Appl. No. 10/673,006
Amdt. Dated August 19, 2005
Reply to Office Action of May 19, 2005

Amendments to the Drawings:

Please amend drawing sheets 1-3, FIGS. 1, 2A and 3 as depicted in the attached “Replacement Sheets” and “Amended Sheets.”

FIG. 1

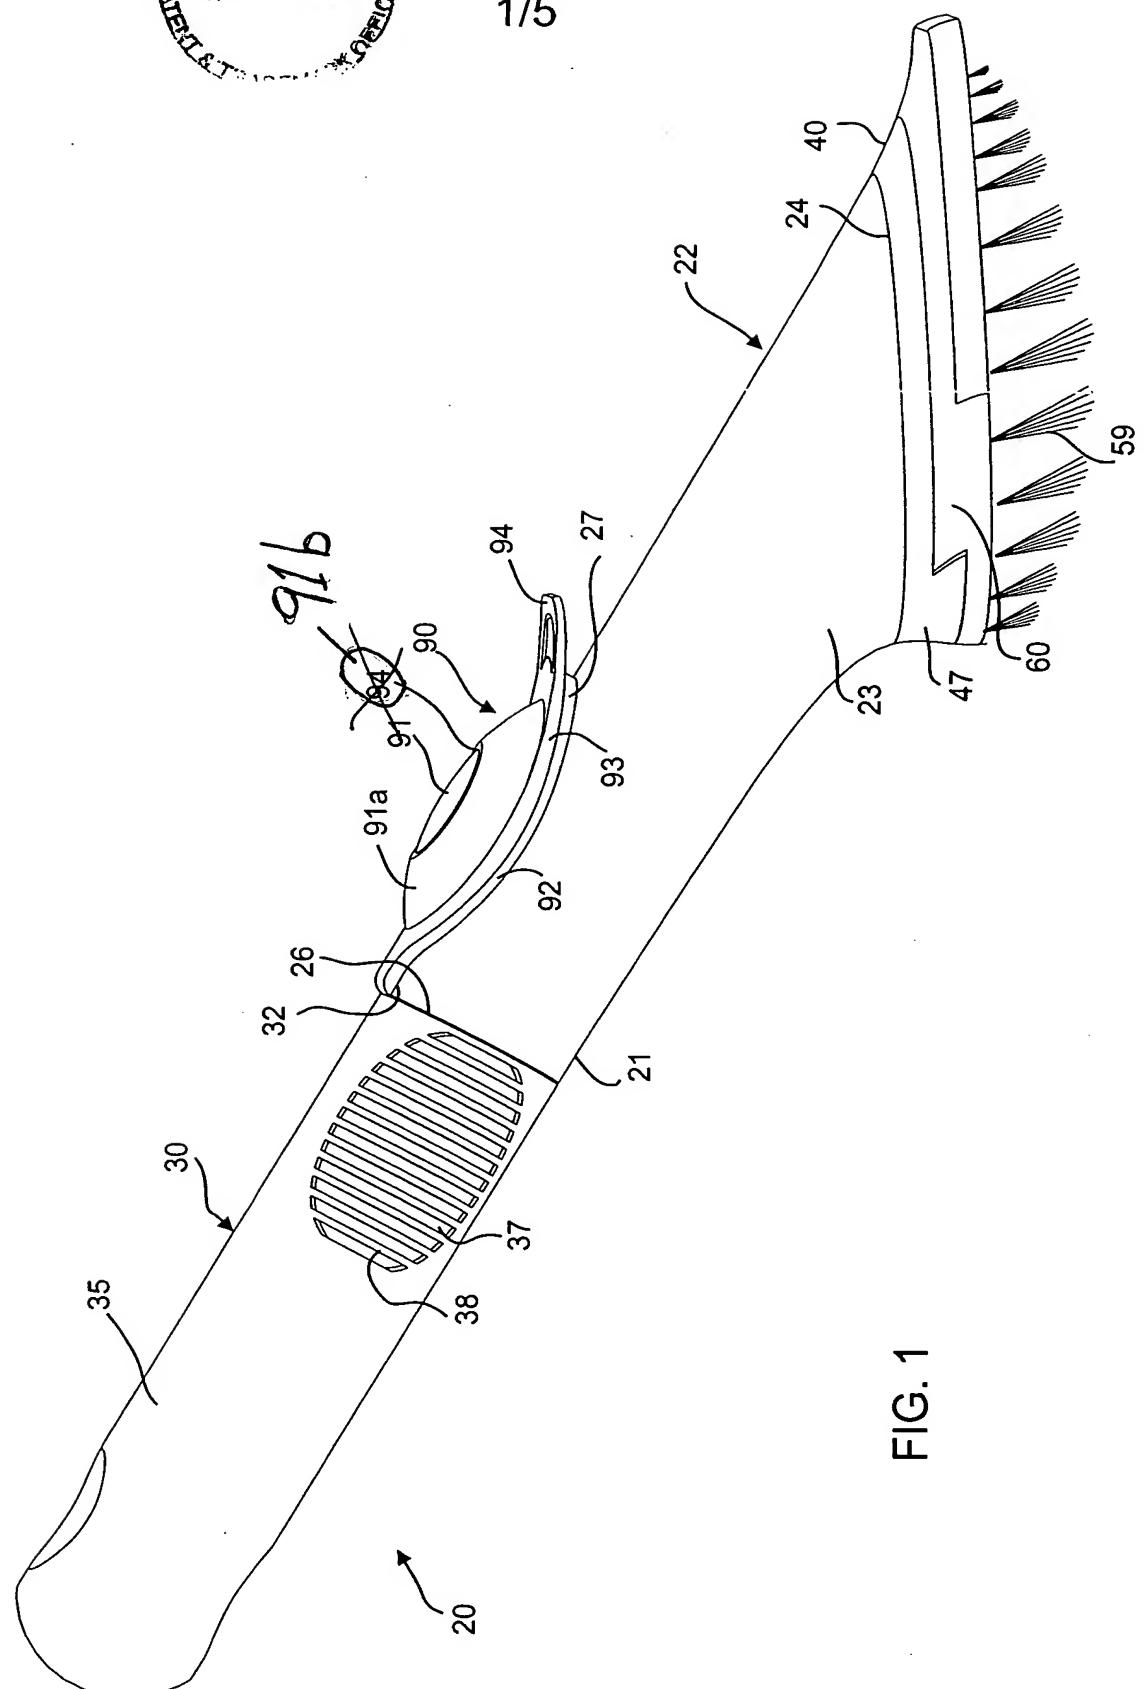
The drawings were objected to with respect to reference numbers 49, 105a/105b, 126 and 101. Applicant has amended the specification and the drawings in order to overcome these objections. The enclosed drawing sheets are submitted in order to correct these errors. Applicant has provided both Replacement Sheets and Amended Sheets showing the changes to FIGS. 1, 2A and 3.
